ADDENDUM
MEETING OF THE PLANNING COMMITTEE
WEDNESDAY 27th MARCH 2024

**PLANNING APPLICATION: 23/00879/F SOUTH PARK SPORTS ASSOCIATION
WHITEHALL LANE REIGATE SURREY RH2 8LG**

**PLANNING APPLICATION: 21/02938/F - BOLTERS CORNER REST HOME
BOLTERS LANE BANSTEAD SURREY SM7 2AB**

PLANNING APPLICATION: 24/00118/F – 40-46 BRIGHTON ROAD, SALFORDS, SURREY

2 (12) GF GIA PROPOSED - New Construction Area Plan
1 : 200 @A0

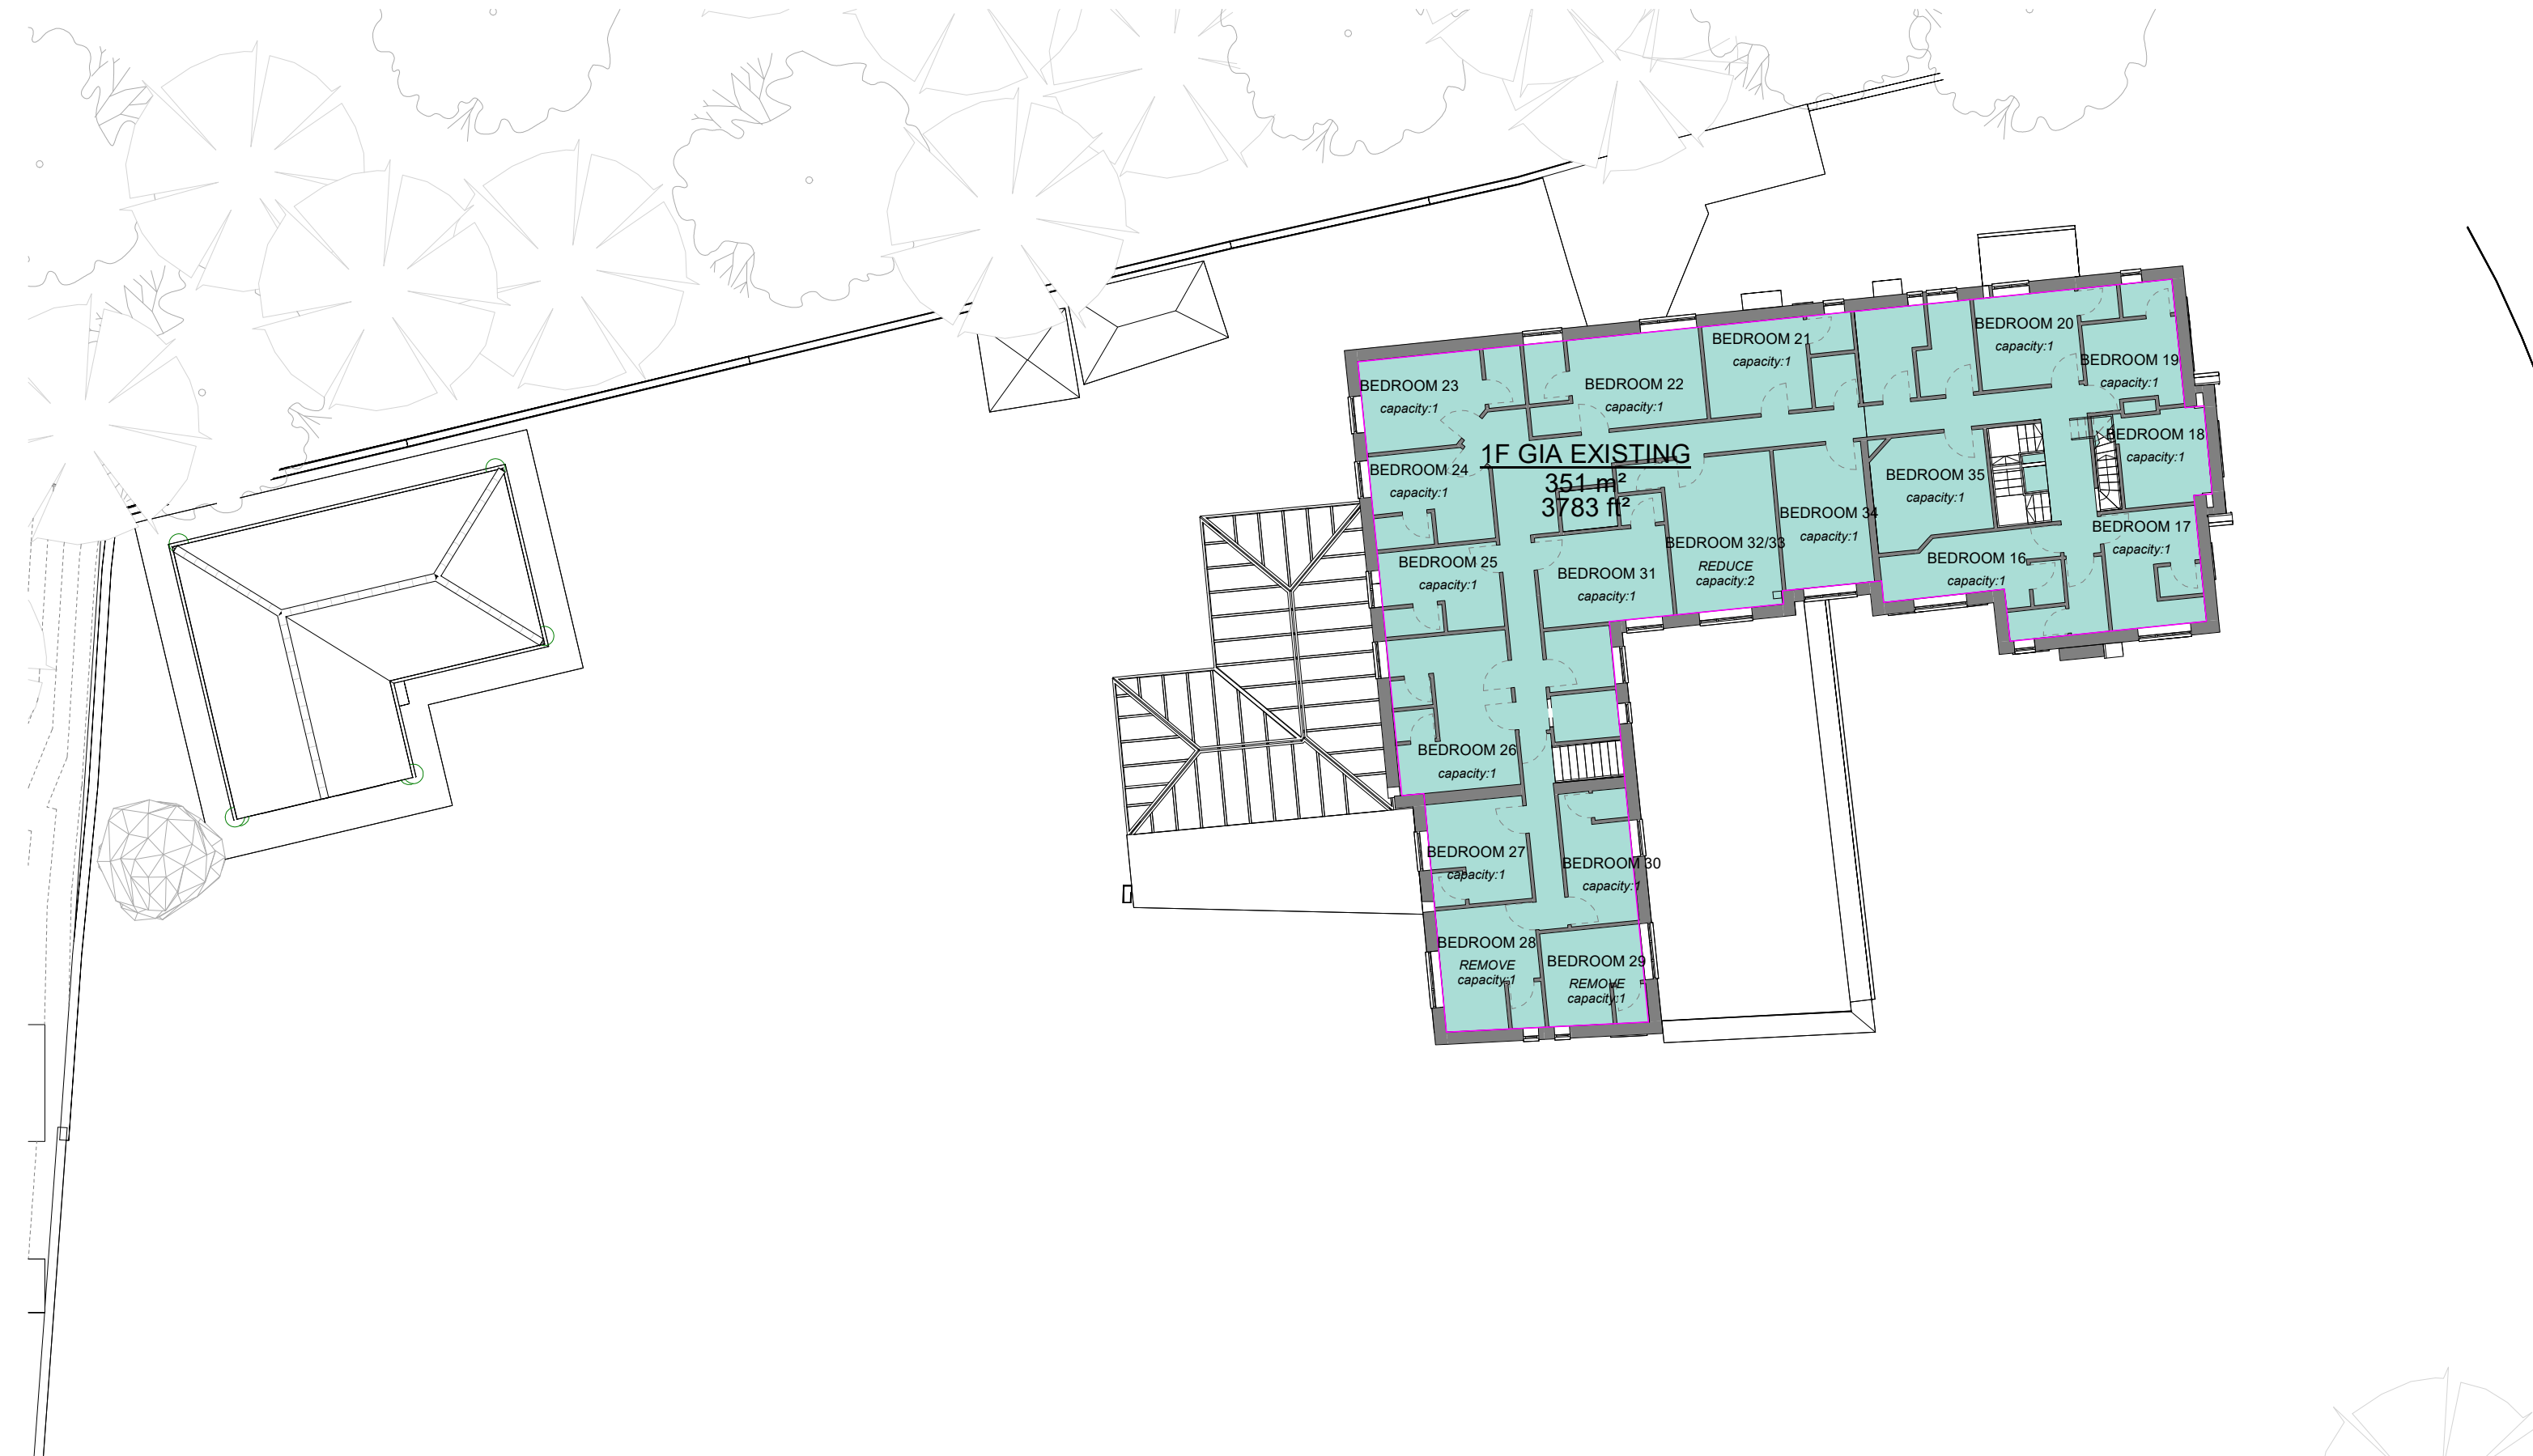
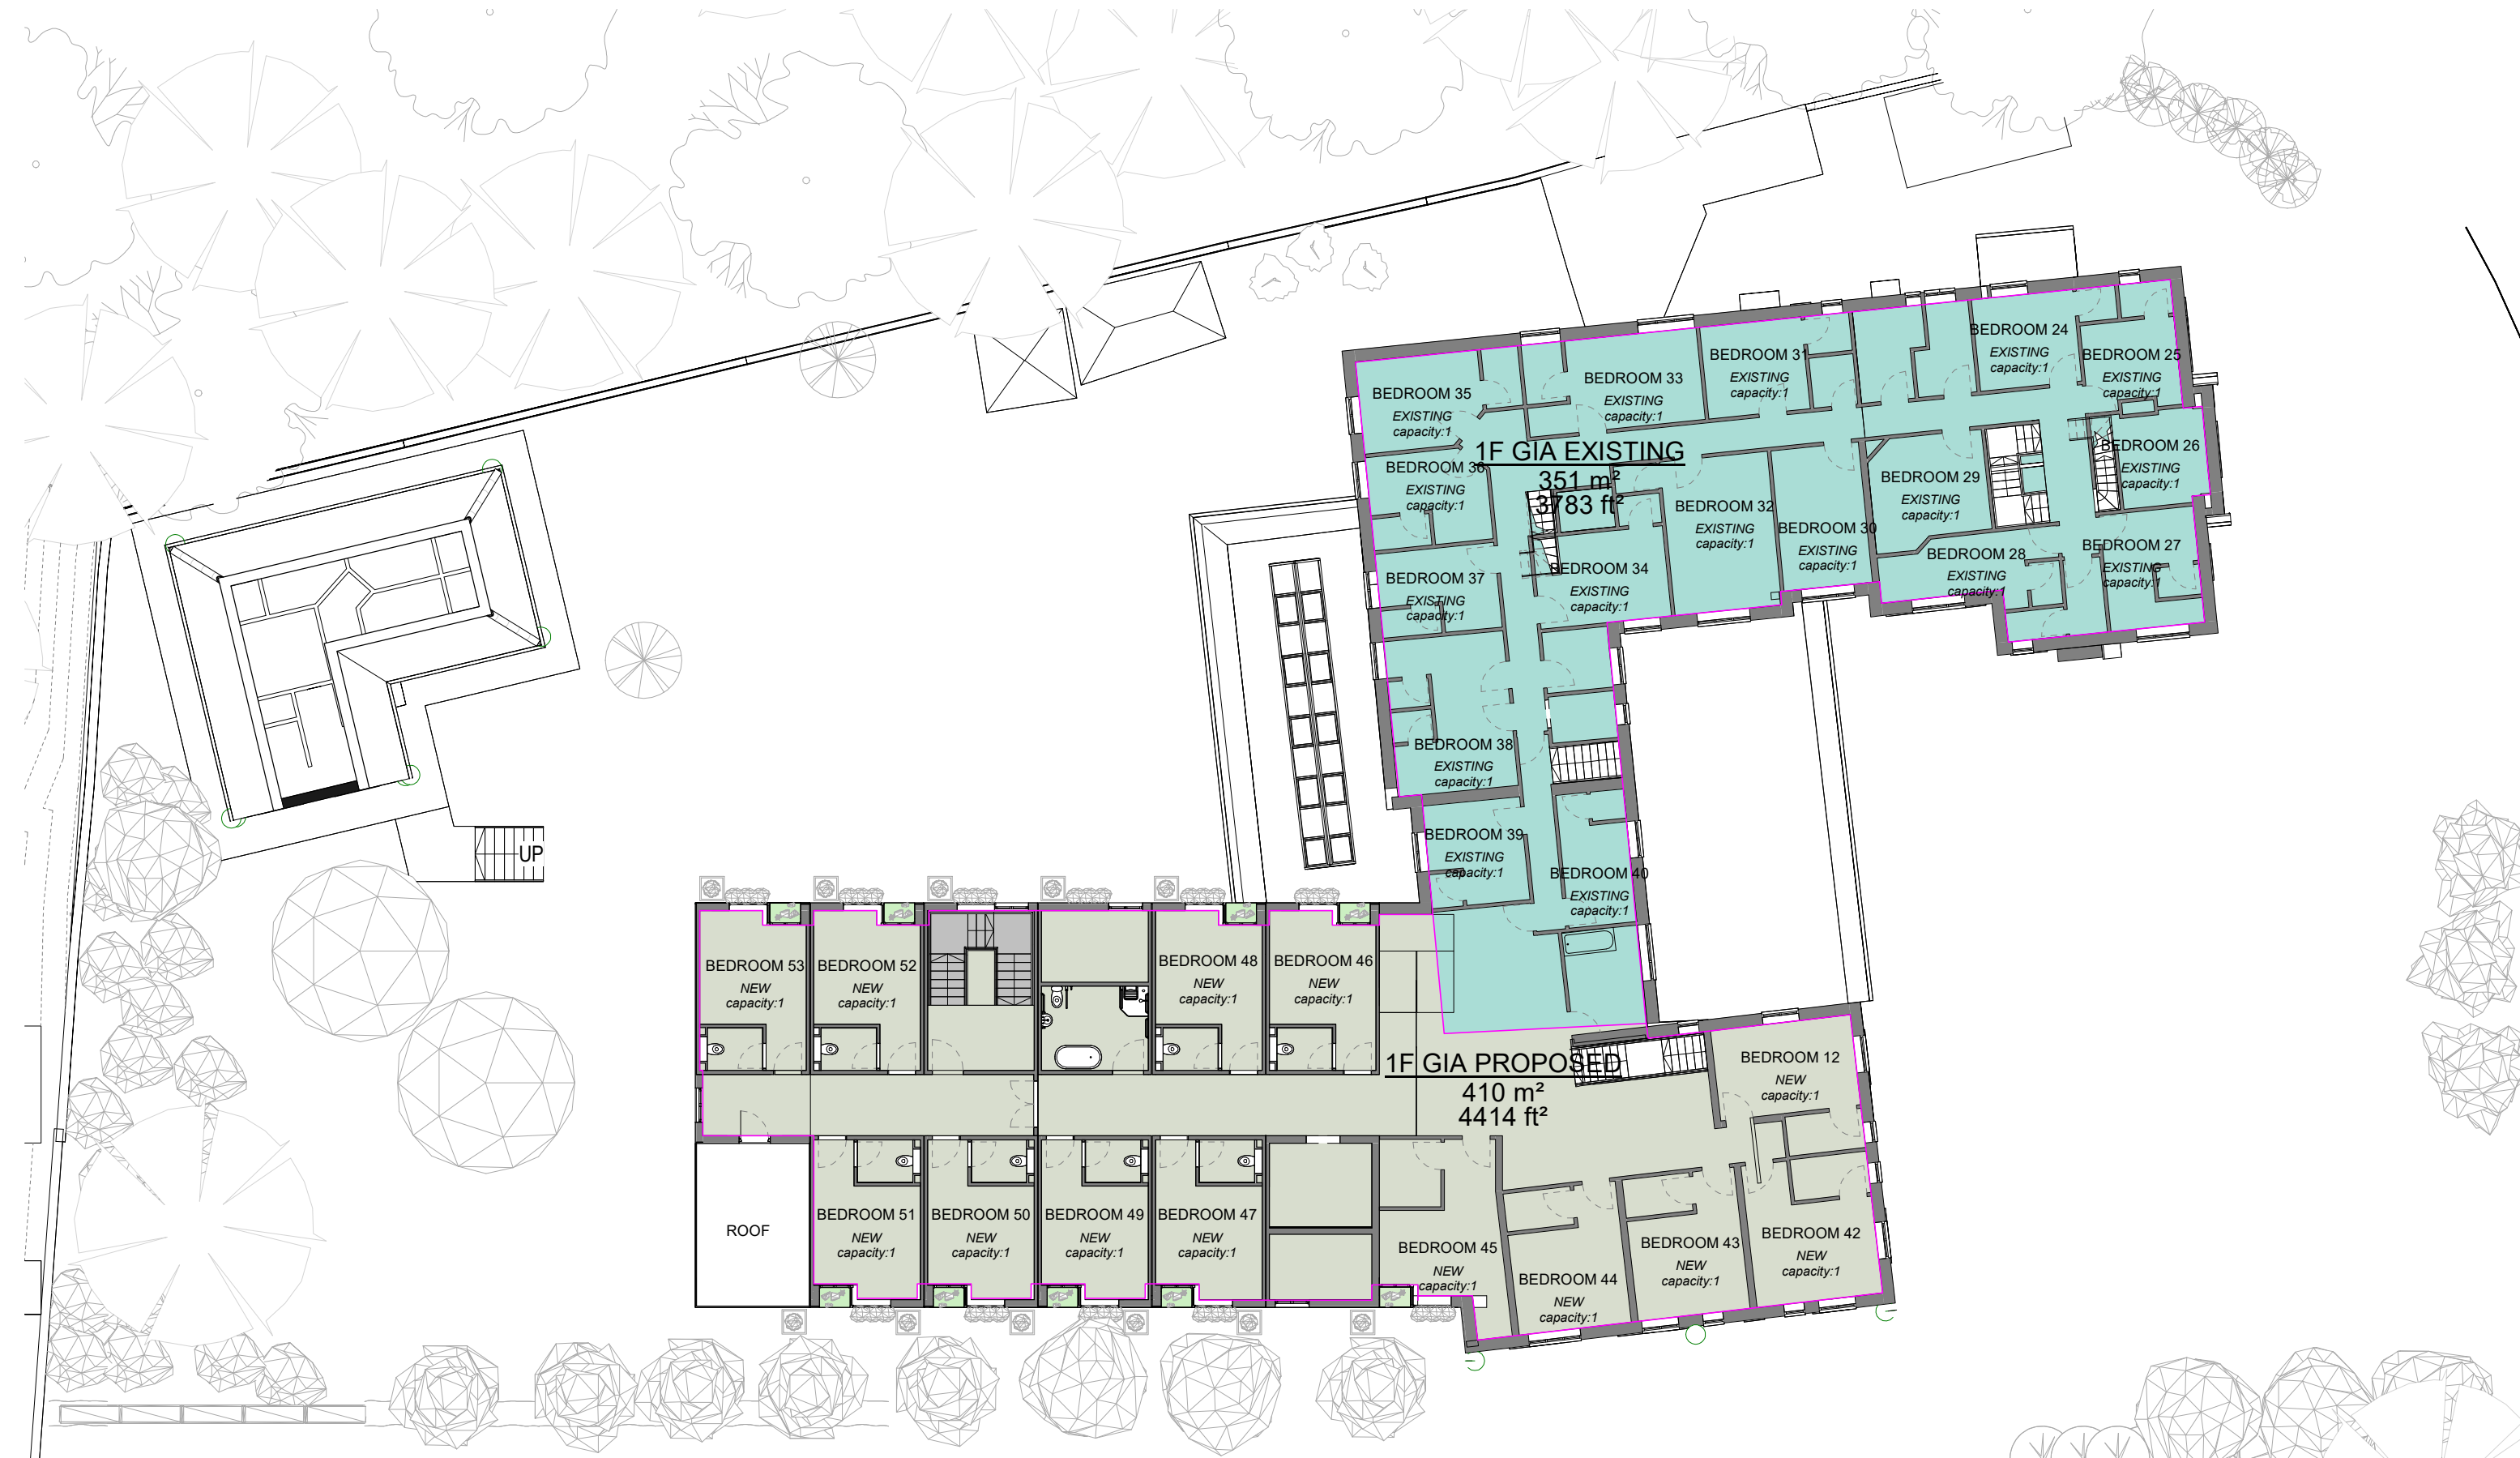
- Updated EXISTING & PROPOSED AREAS & BEDROOM SCHEDULES drawing, 2255-IDL-NA-ZZ-DR-A-12001 (**Appendix C of addendum**)

| 3.11 180324/REVISED PLANNING | HWSG |
